**Statement of Response to
Pre-application Consultation
Opinion**

**Lands at Broomhill Road,
Tallaght, Dublin 24,
D24 XA52 and Unit 51 Broomhill Road,
Tallaght, Dublin 24, D24E124**

SHD – Residential & Mixed Use Development

**On behalf of
Garyaron Homes Ltd.**

Proposed Development and Possible Connections to Future Development in Broomhill

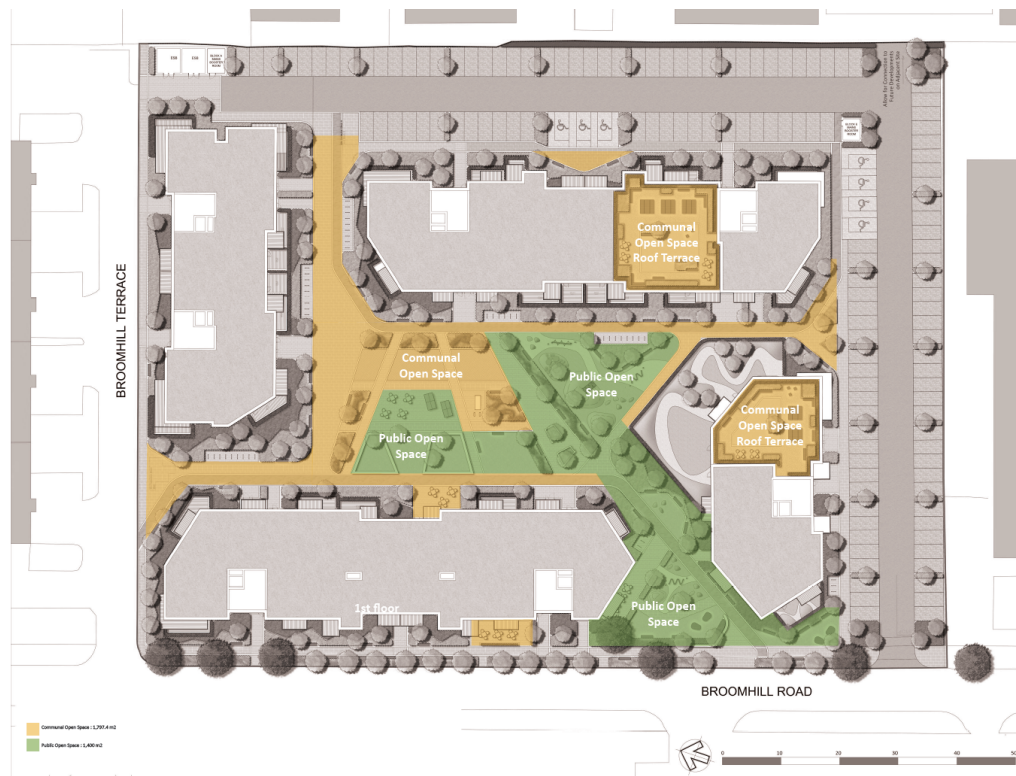
2. Drawings and other documentation demonstrating how the proposed development will relate to, and facilitate future connections with, adjoining lands to the south and east and any potential future development thereof.

An Bord Pleanála has requested drawings that the applicant demonstrates the proposed development’s capabilities to connect with future adjoining developments as well as drawings that clearly define public open space and communal open space to be provided within the development.

The proposed development at Broomhill Road will include an on-site perimeter road for parking. This road can be used to connect into future developments to the south and east.

A hammerhead at the corner of the perimeter road will be included to allow for a future road to the east to connect to the road and for a connection to the wider Broomhill Road area across the site.

There is also a potential to connect to the existing Broomhill Terrace to the north if it is extended in the future. This would allow the proposed development to become part of a broader improved circulation network in Broomhill.

Sustainable Urban Drainage Systems

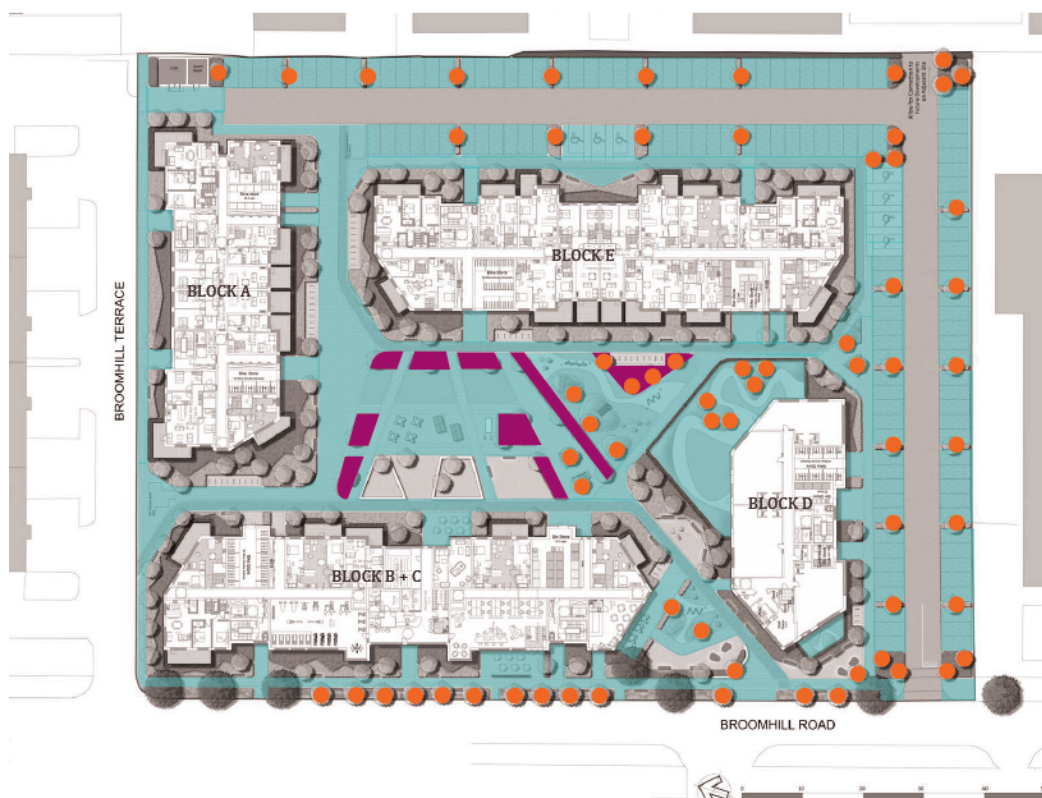
The Landscape proposals shall include site-specific enhancements to achieve biodiversity net gains. Green corridors can be used to extend and enhance existing ecosystems. Biodiversity net gain delivers measurable improvements for biodiversity by creating or enhancing habitats in association with development. The development proposals shall include a network of multifunctional green space, which is capable of delivering a wide range of environmental and quality of life benefits for local communities. The Public Realm Section welcomes the provision of the following SUDS features within the development proposals:

- Permeable paving
- Rain Gardens
- Tree pits

Details of landscaping and proposed SUDS can be found in documentation produced by Park Hood Landscape Architects and Kavanagh Burke Consulting Engineers. The below graphic contained in the Parkhood Landscape Plan illustrates areas of permeable paving (blue) Bio retention areas (purple) and Tree pits (orange).
